STEP BY STEP EARLY LEARNING CENTER	EXISTING CONDITIONS
---------------------------------------	---------------------

STEP BY STEP
EARLY LEARNING CENTER
DEMOLITION & TESC PLAN

C3.01

C6.10

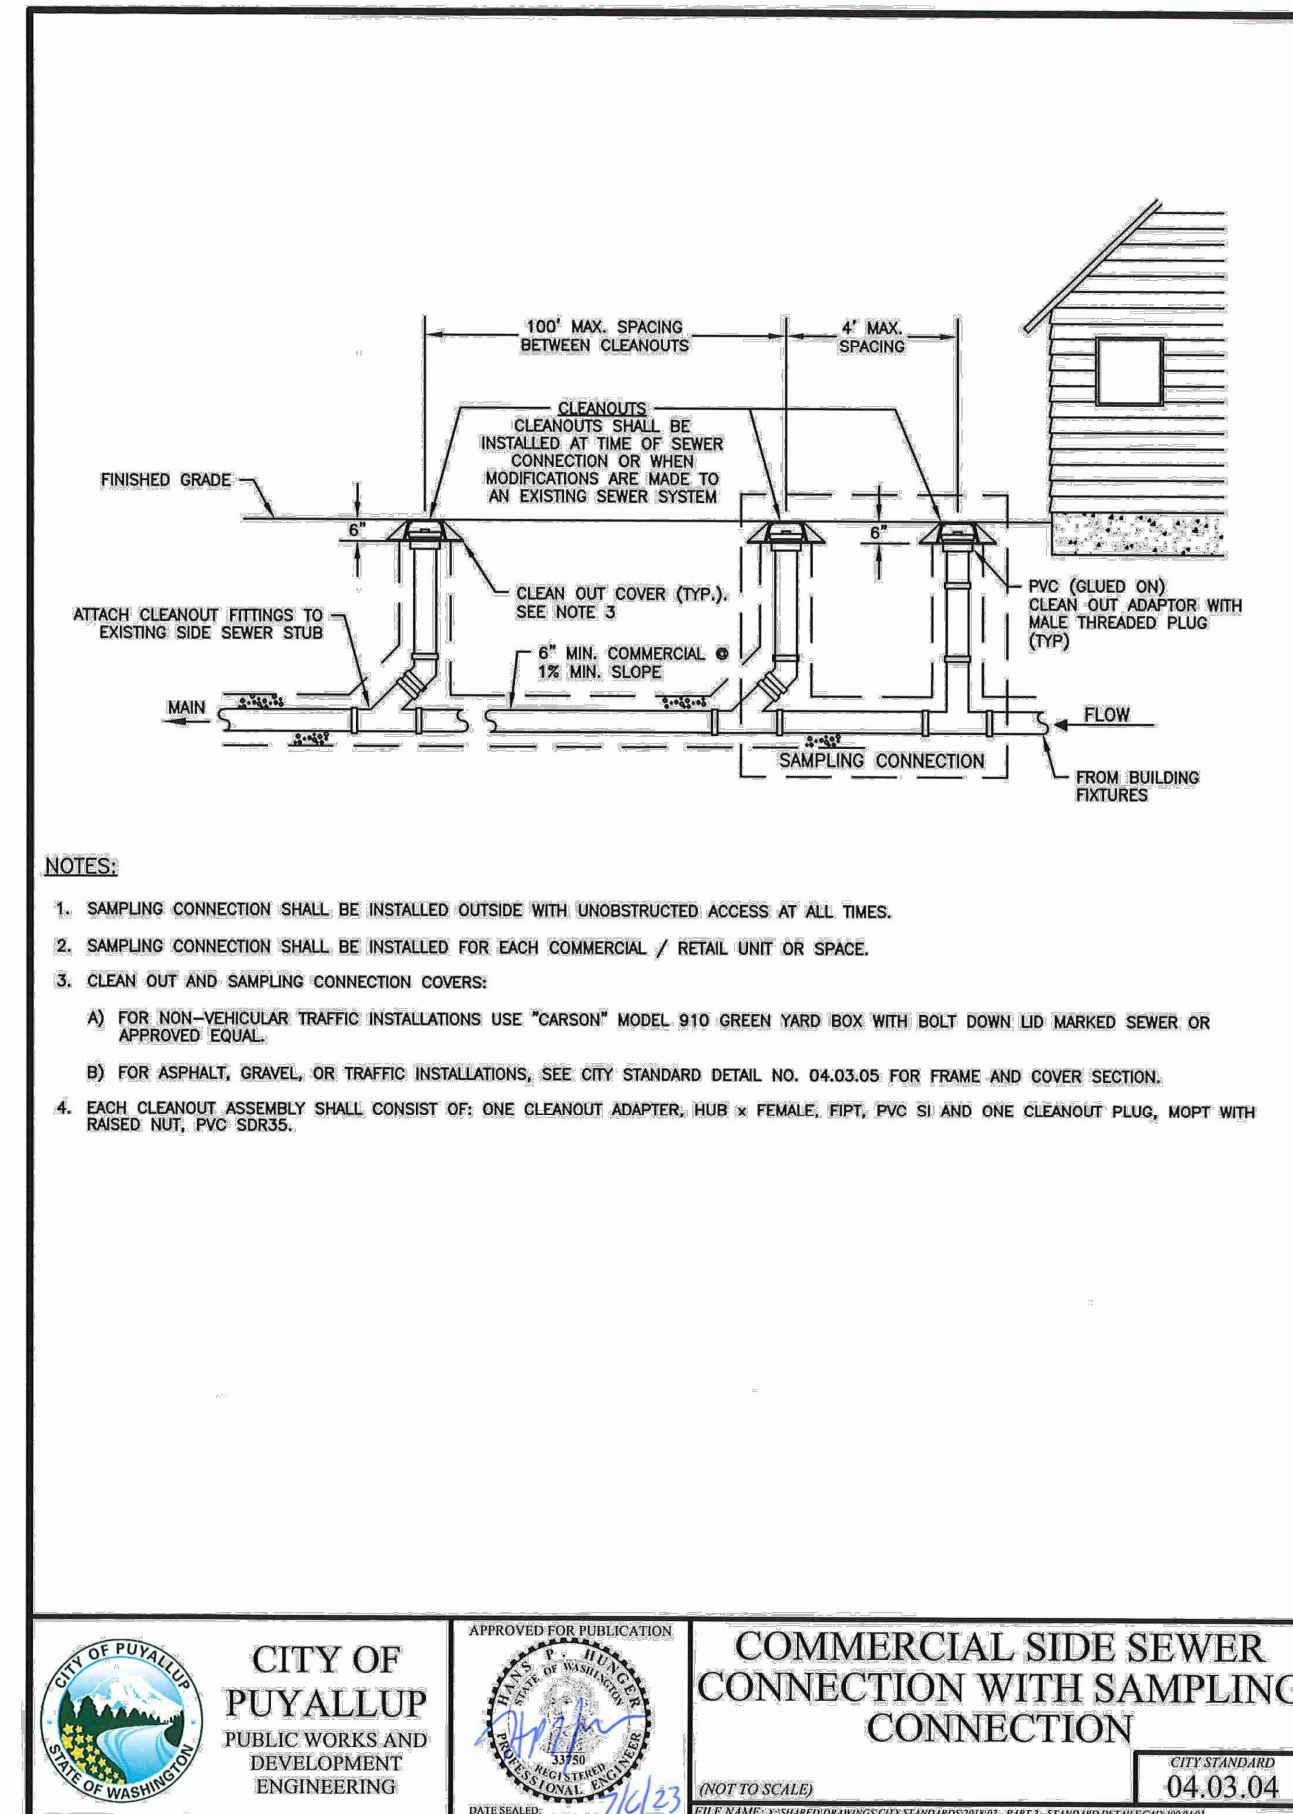
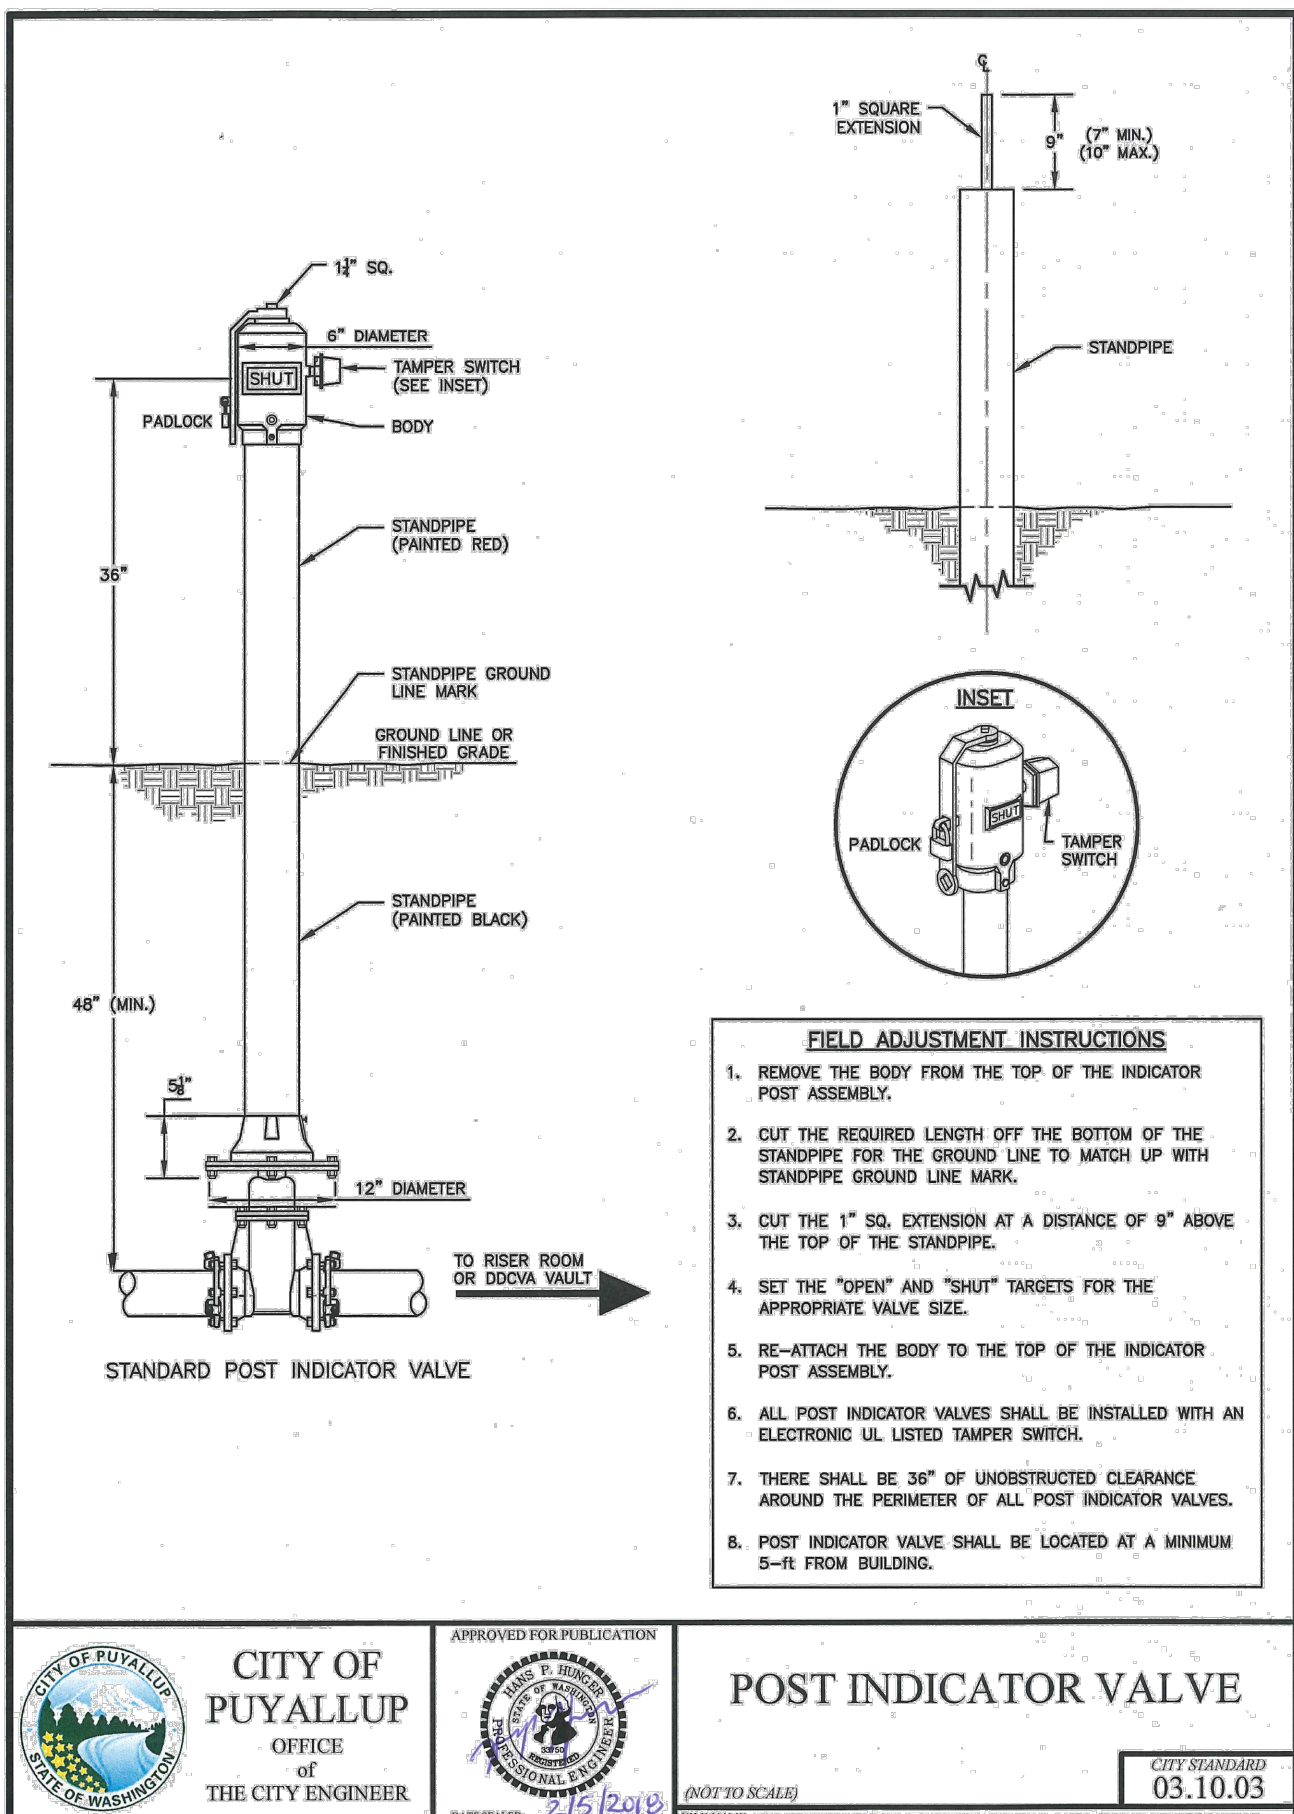
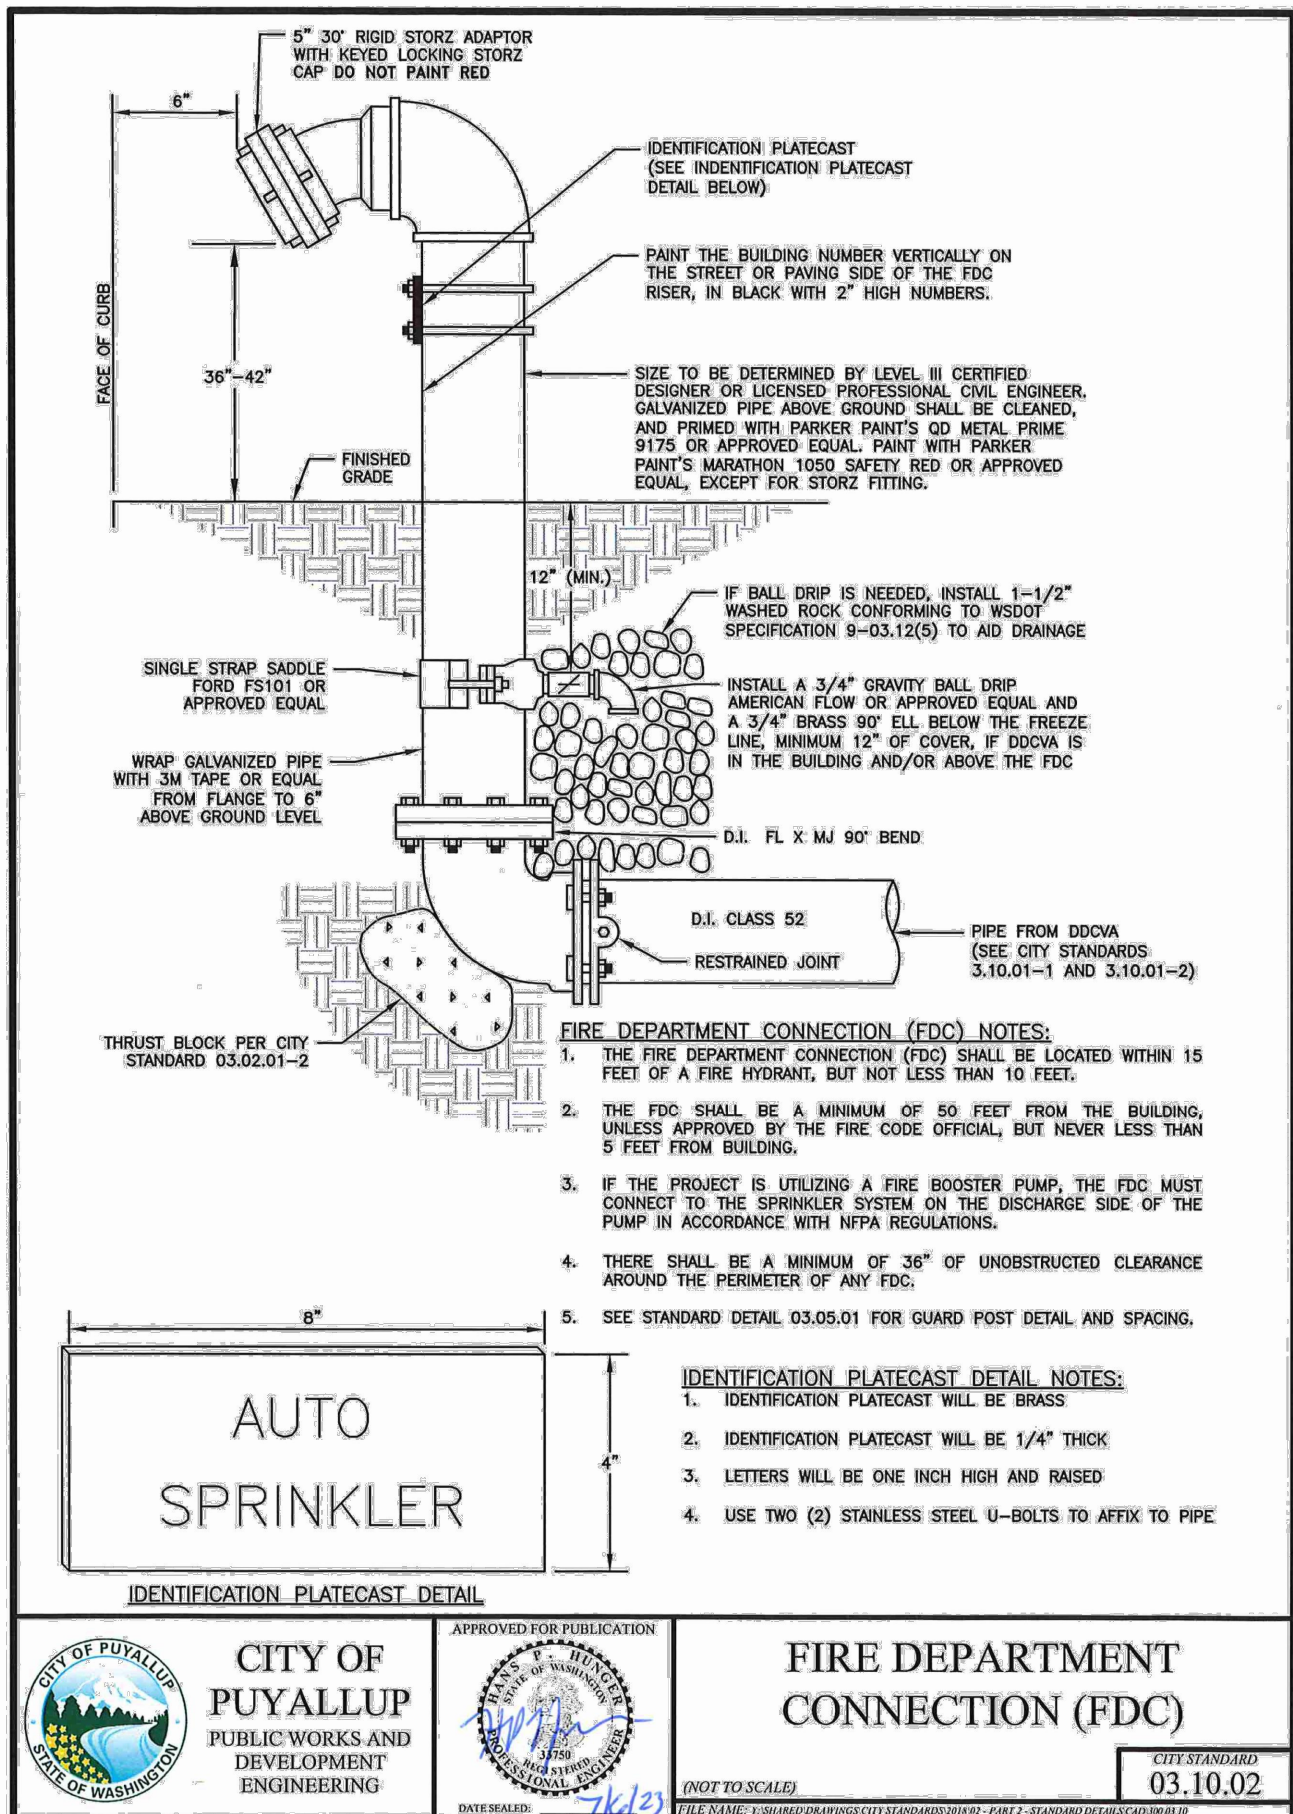
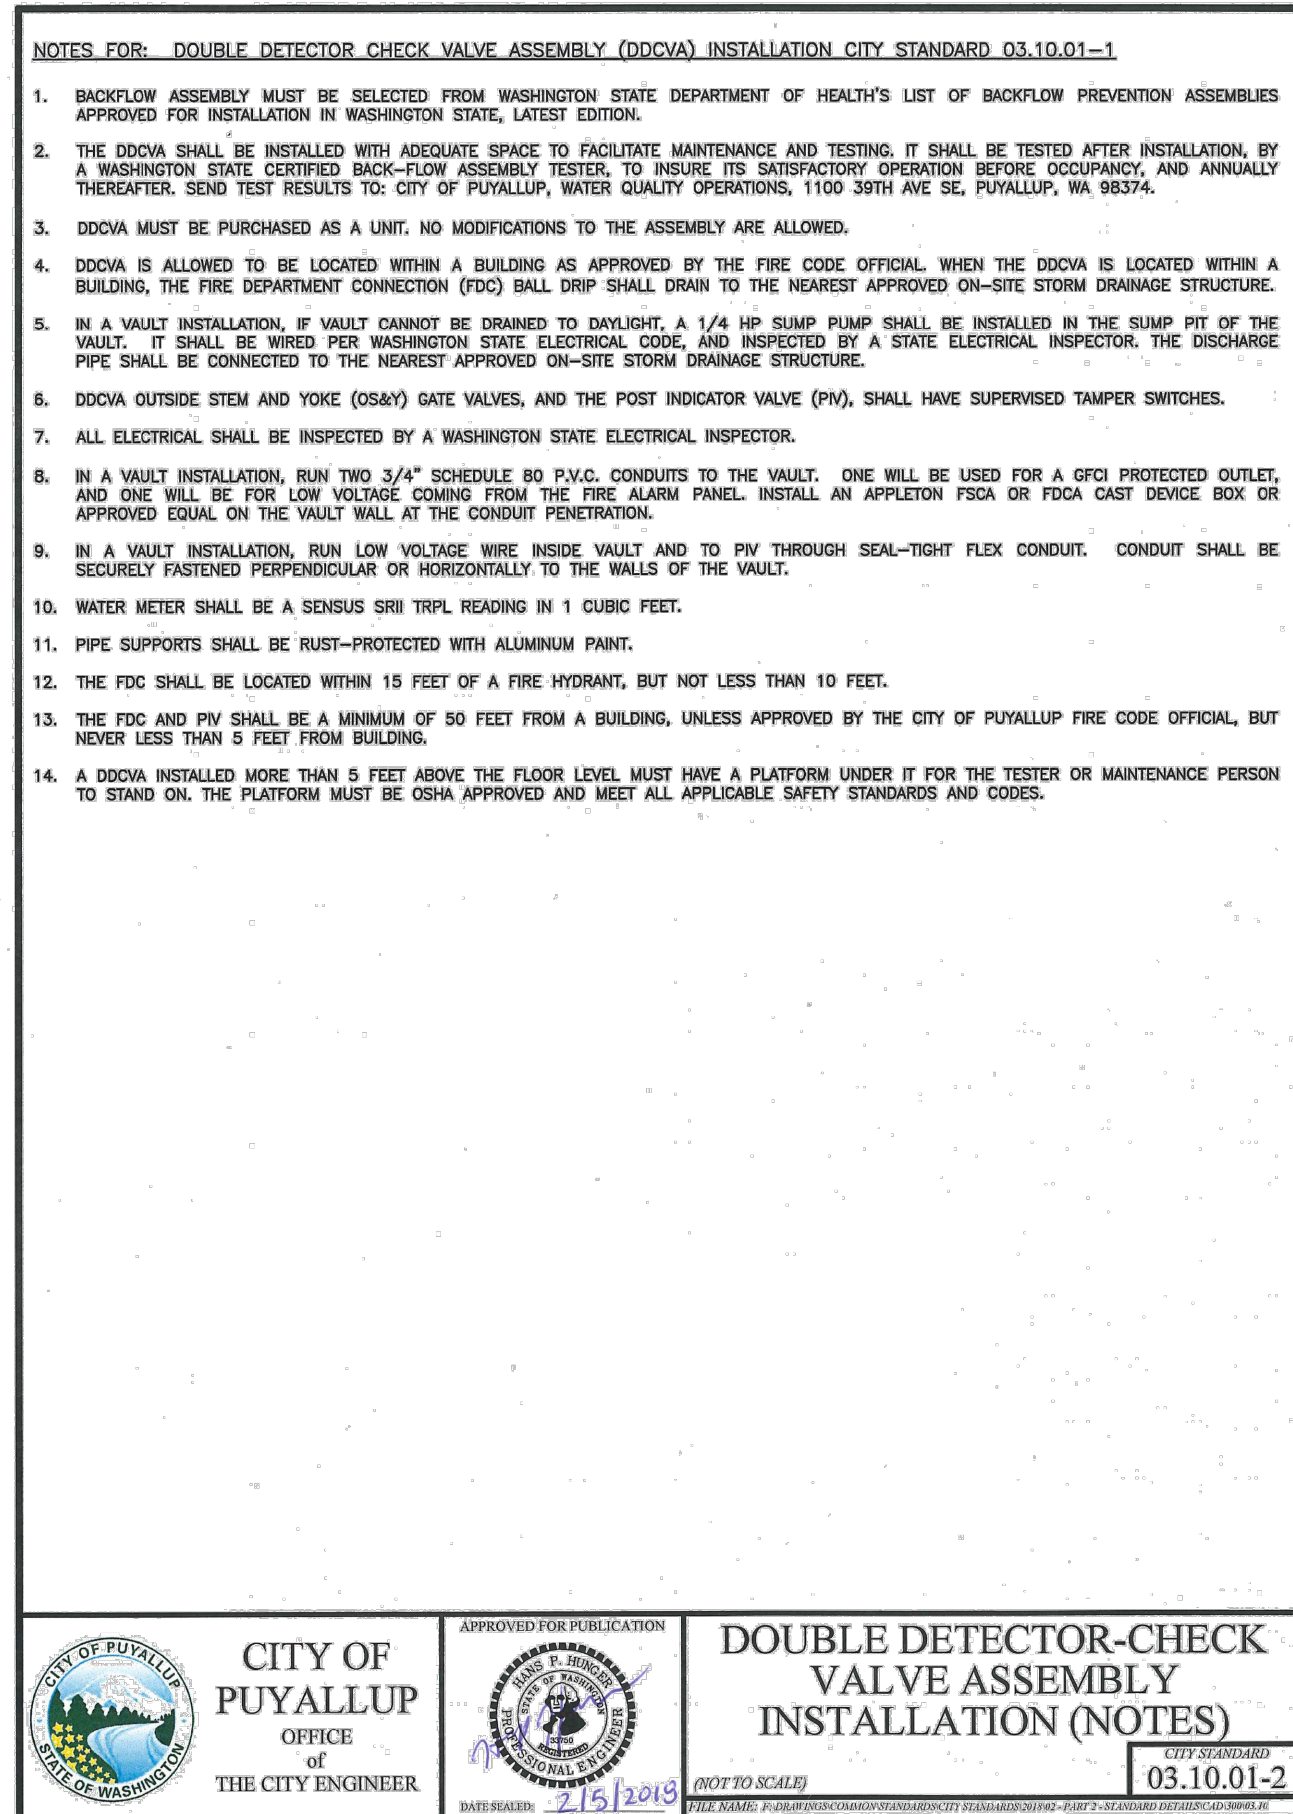
Add City Standard Details:
03.05.01 // 03.11.01 // 04.03.05 //
[Plans; Sheet C6.10]

Details have been added.
